Re: 200 Wells Avenue/Russian School of Mathematics

**Re: 200 Wells Avenue Site Lighting**

PROPOSED SITE LIGHTING PLAN

TOPOGRAPHIC SITE PLAN  
NEWTON, MASSACHUSETTS  
SHOWING THE PROPOSED  
200' WIDE EASEMENT AT  
SCALE 1"=20'  
DATE: AUGUST 2, 2013  
PROJECT: 20137

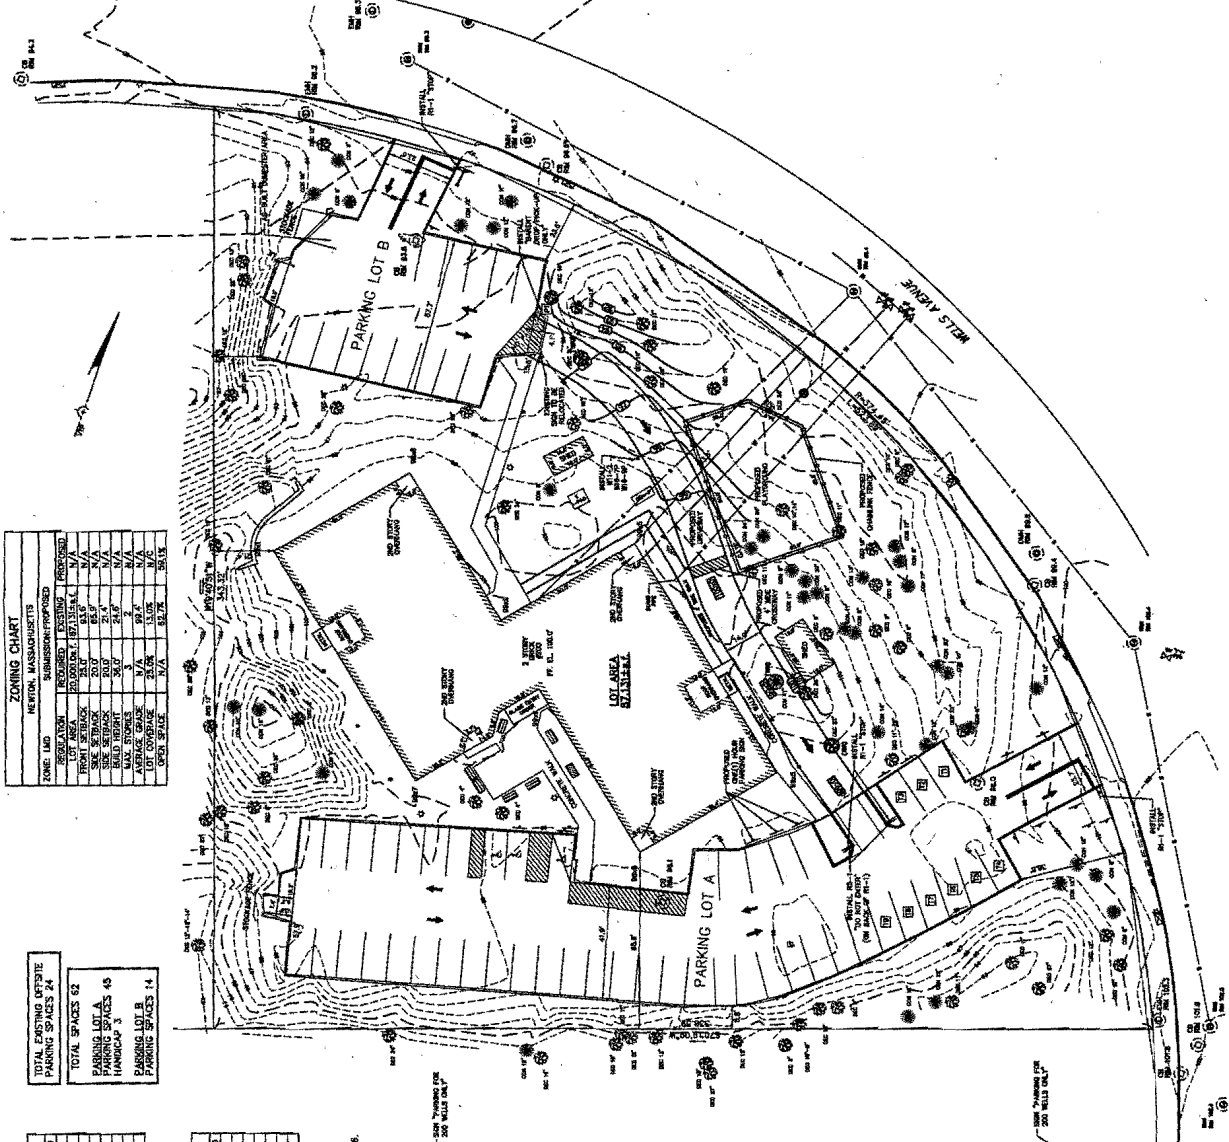
1. Letter to me from Donald Lang of DLA Architecture dated August 1, 2013 addressing lighting at the site.
2. A lighting plan showing existing and proposed lighting at the site, which should be viewed in connection with item 1, above.
3. A revised site plan from VTP Associates, Inc. dated August 2, 2013 which shows nine parking stalls designated as staff parking near the entrance to Lot A, as suggested by Alderman Fischman.

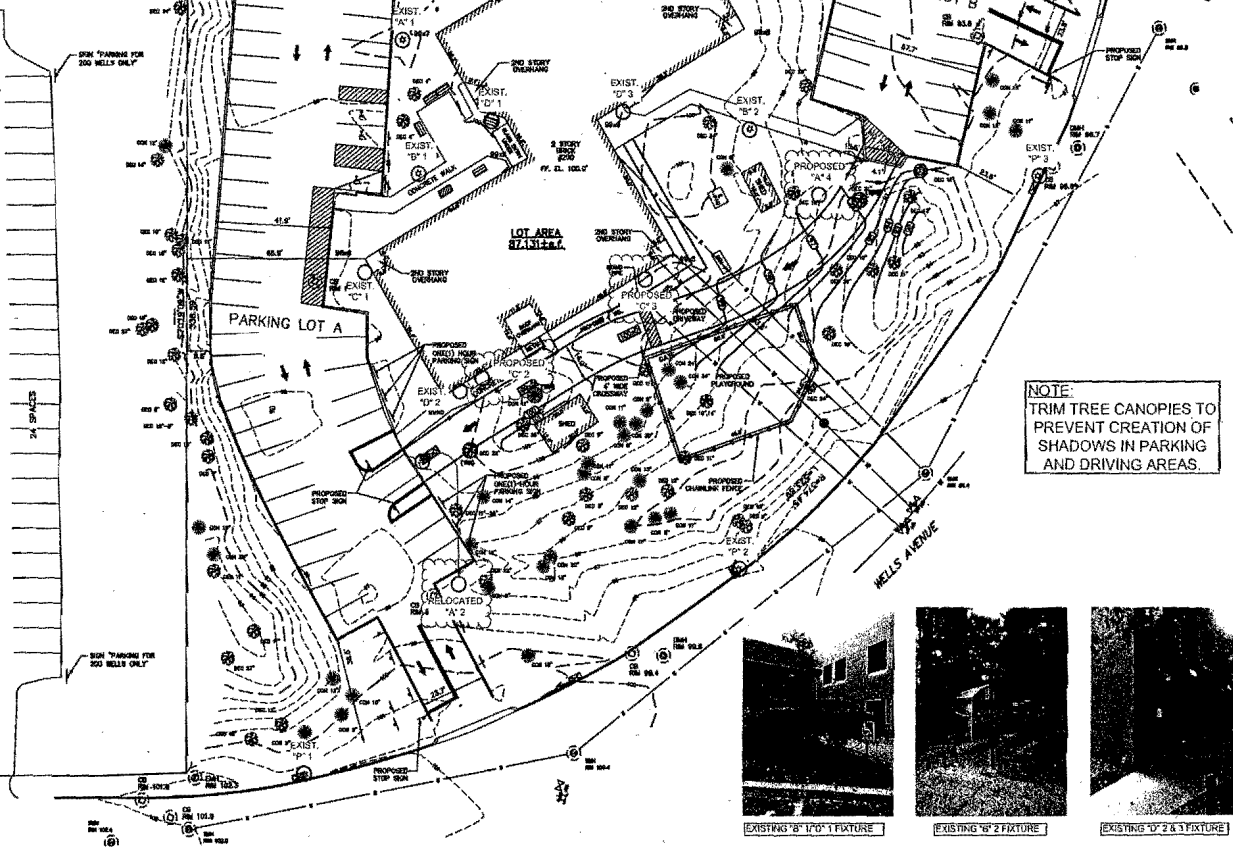
The lighting level at the entrance of parking lot A was less than adequate as Alderman Fishman had suggested. We will improve that by relocating the pole light (type A on our plan) which is currently located at the eastern end and in the center of the proposed drop off driveway approximately 50' toward Wells Avenue where the fixture will nicely light the entrance drive driveway and adjacent parking area once the trees are trimmed.

The lighting level at the entrance of parking lot B will be adequate once the burned out lamp on the adjacent pole light (type A) in parking lot B is replaced. Even with the missing bulb, the meter reading was within .1 FC of an acceptable level. There is an existing city street light (type P on our plan) very close to the B lot entrance. We have indicated all of the city lights on our plan.

The engineer's discussed the possibility of adding an additional pole lighting fixture (type A) near the western end of the proposed drop off driveway near its entrance from parking lot B. The engineers will make a recommendation for this area when they have completed their calculations.

The engineer's believe that two or three additional wall-mounted lighting fixtures (type C) should be located near the top of the existing building wall above the proposed drop off driveway to adequately illuminate the full length of the new driveway. These fixtures will be similar or identical to the existing type C fixture mounted on the building wall closest to parking lot A near the main entrance walkway to the building.

I enclose our revised illustrated architectural site plan dated 8/1/13 with modifications to the lighting reflecting our site visit for your review and consideration.

NOTE: TRIM TREE CANOPIES TO PREVENT CREATION OF SHADOWS IN PARKING AND DRIVING AREAS.
